Phoenix Ironworks

Design Changes Justification  
Document

PIW-PRP-ZZ-ZZ-TR-A-100003

PRP Architects have been appointed by EWC and Manchester Life Development Company to submit a Non-Material Amendment Application (section 96a) to formally approve the changes to the original planning application prepared by CallisonRTKL (now Arcadis).

Core 2

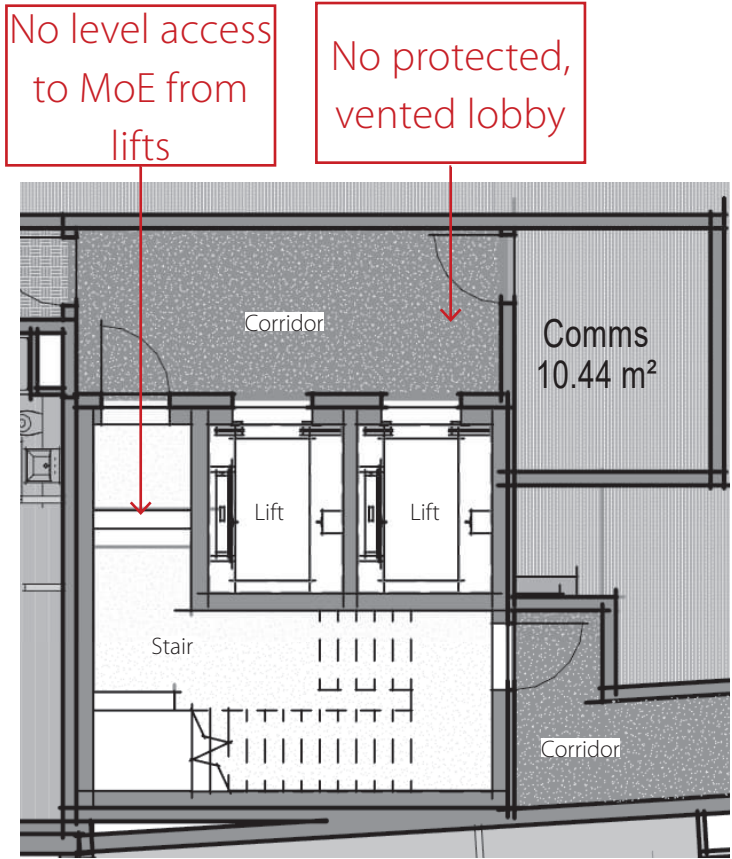
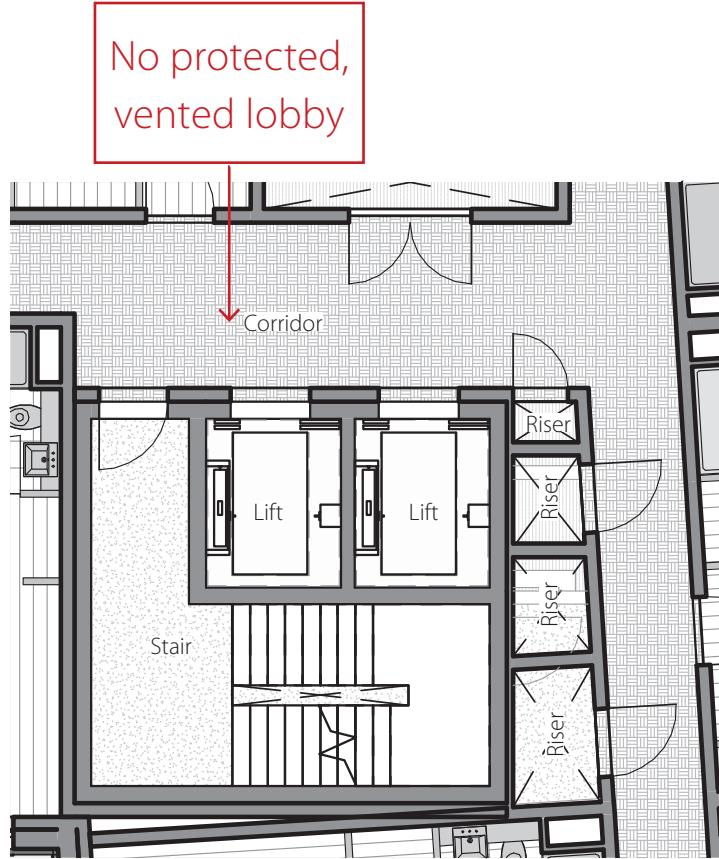
In addition to the newly introduced requirement to provide ventilated fire-fighting and evacuation lobbies, the original design of Core 2 did not incorporate a level escape route at the point of final exit.

To address this, we have revised the layout to include a compliant level escape route via internal ramps, designed in accordance with Part M.

Core 3

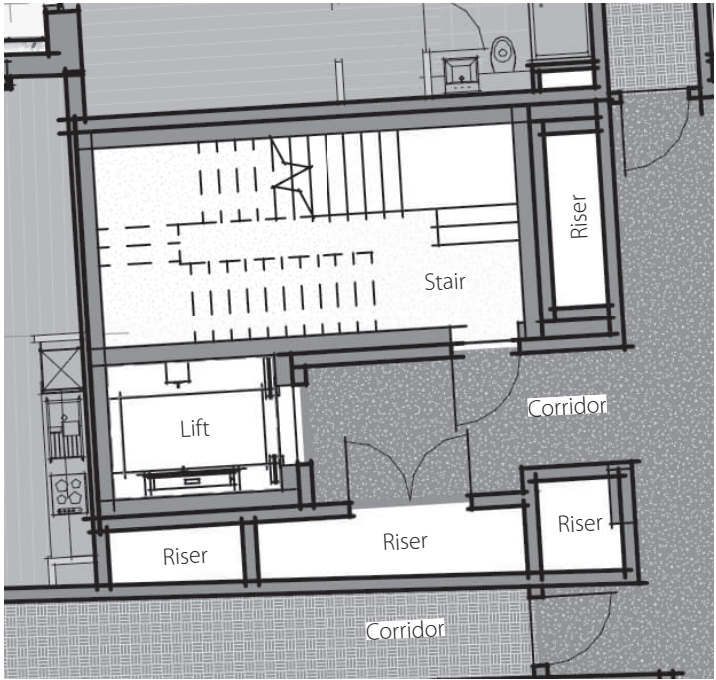
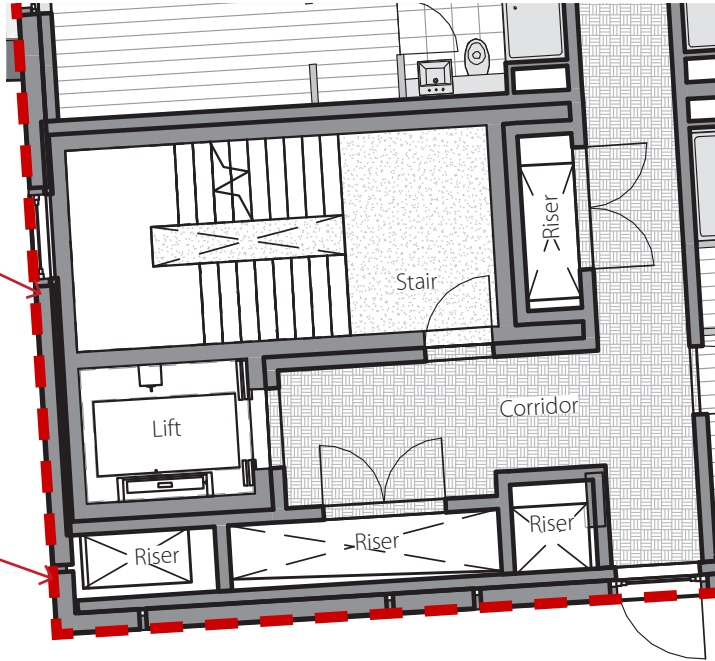
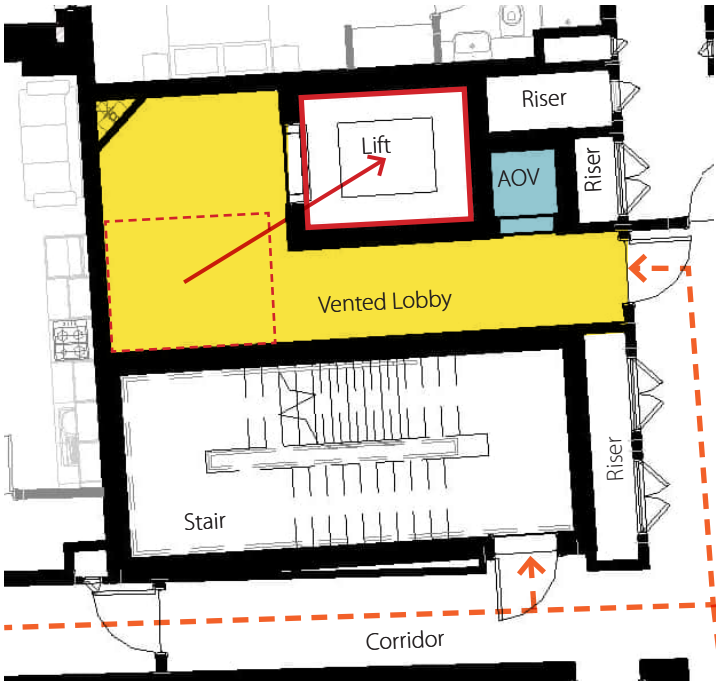
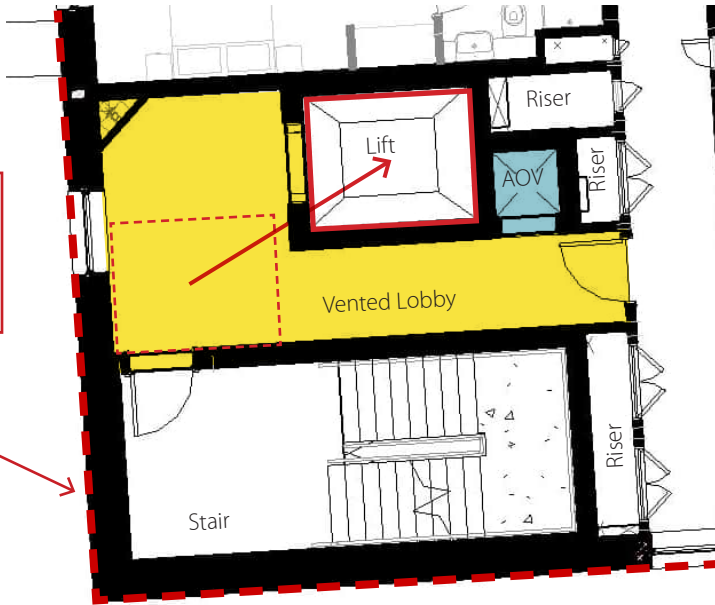
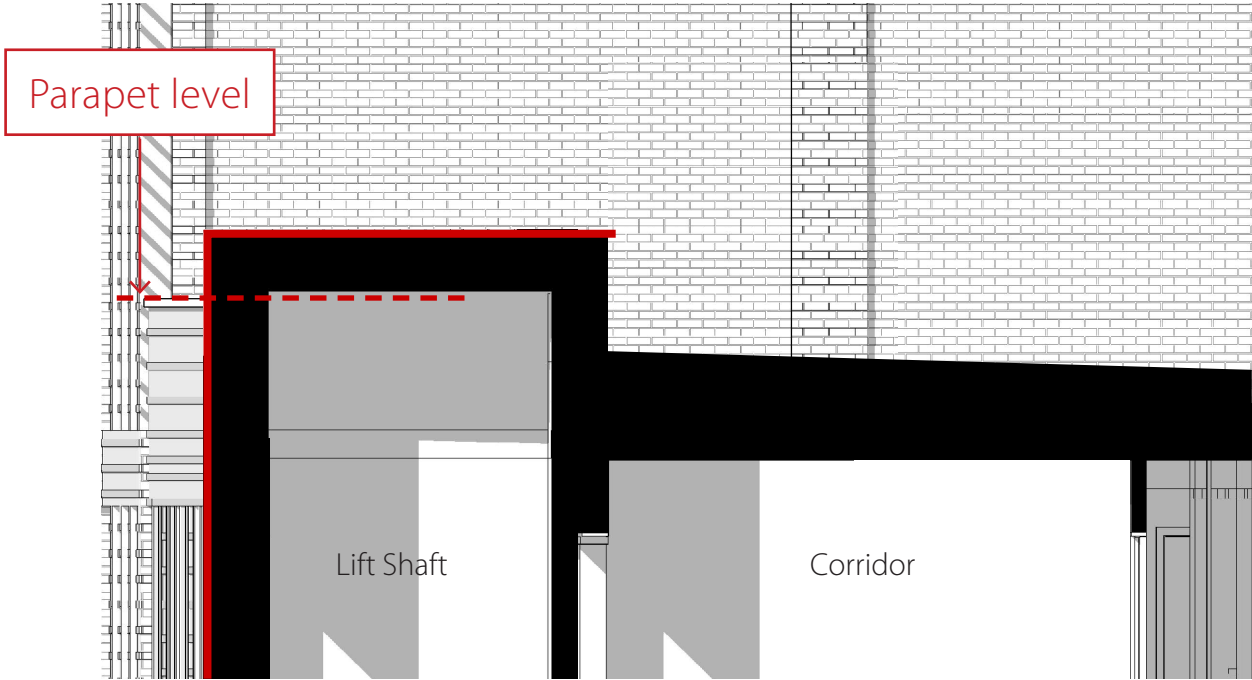
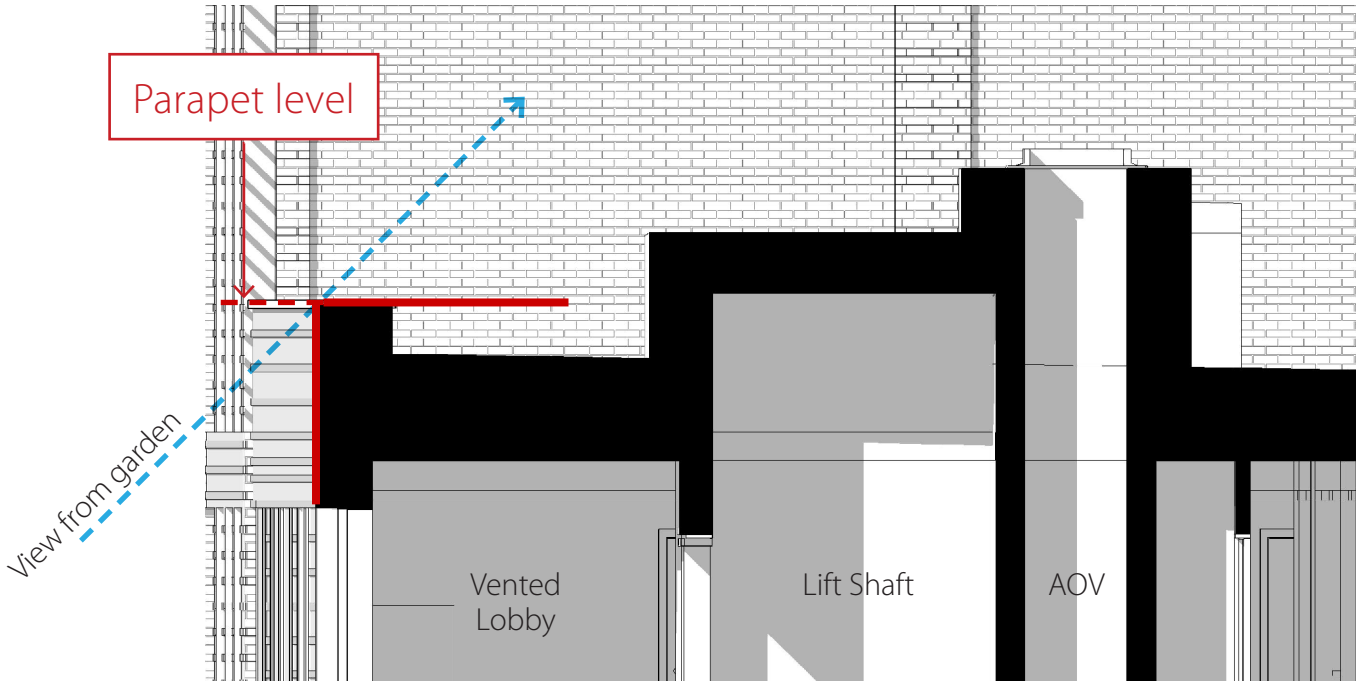
As with Core 1, we have relocated the riser in Core 2 to allow for direct access at the top floor, improving serviceability and future maintenance.

In addition, we have incorporated a naturally ventilated fire-fighting and evacuation lobby in accordance with the updated requirements of BS 9991:2024.

Core 4 - Escape Stair and lift

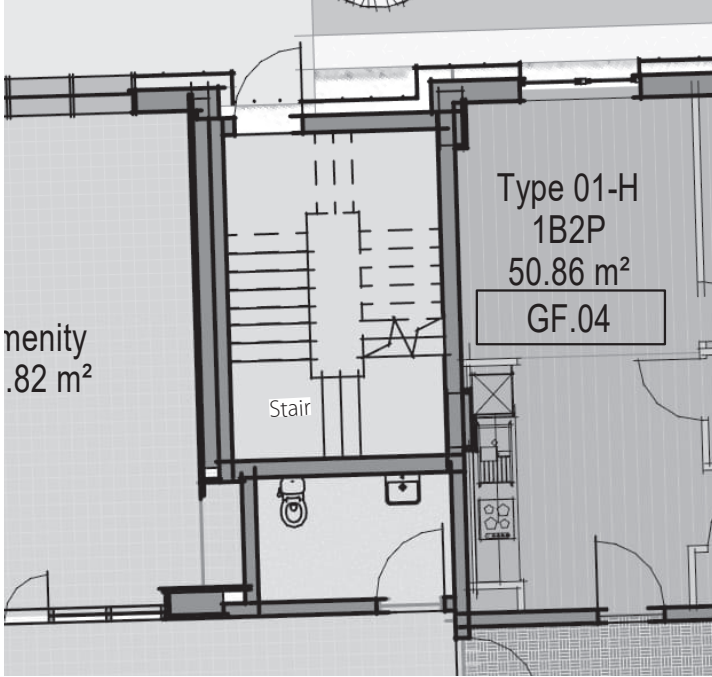
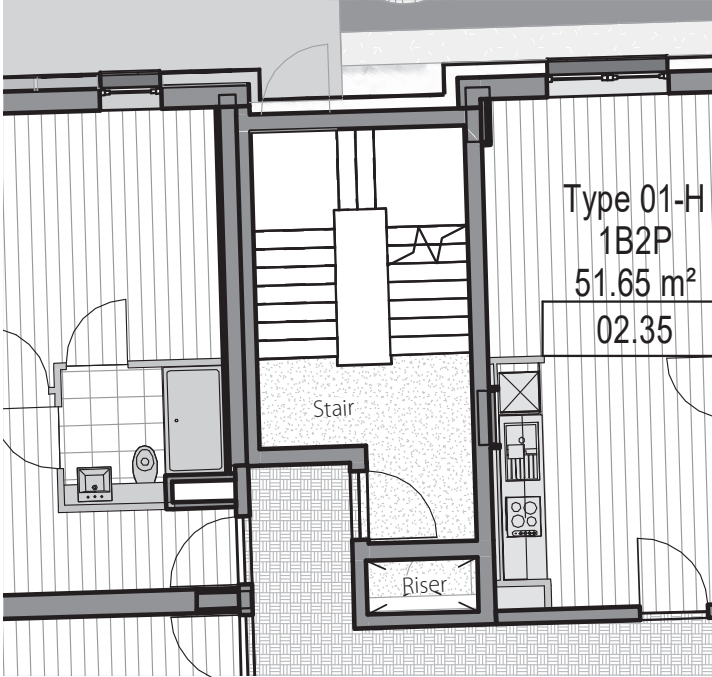
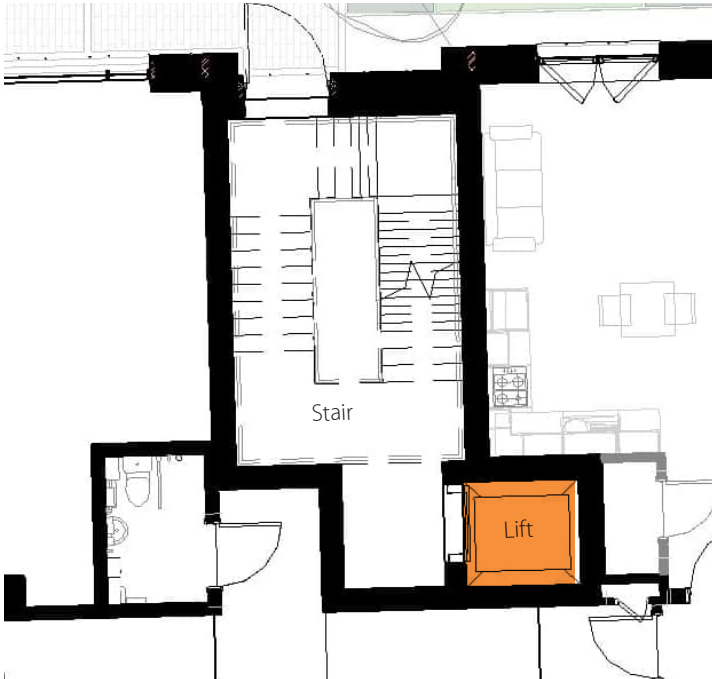
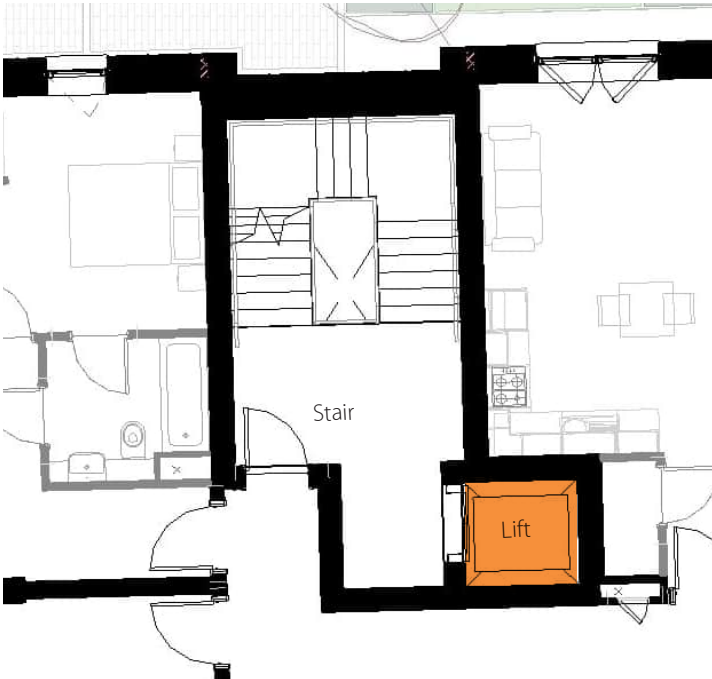
In accordance with BS 9991:2024, each individual stair core must be served by an evacuation lift to provide a safe and inclusive means of egress for all occupants, including those with reduced mobility.

The original consented scheme did not include an evacuation lift for this core. To ensure compliance with the updated guidance, an evacuation lift has now been incorporated into the design.

Additionally, because Core 4 extends only up to Level 4 and serves a portion of the building with a height below 18 meters, the provision of a vented lobby is not required. This exemption aligns with the relevant fire safety provisions outlined in BS 9991:2024, which allow for reduced ventilation requirements in lower-rise sections of a building where the risk profile differs from taller structures.
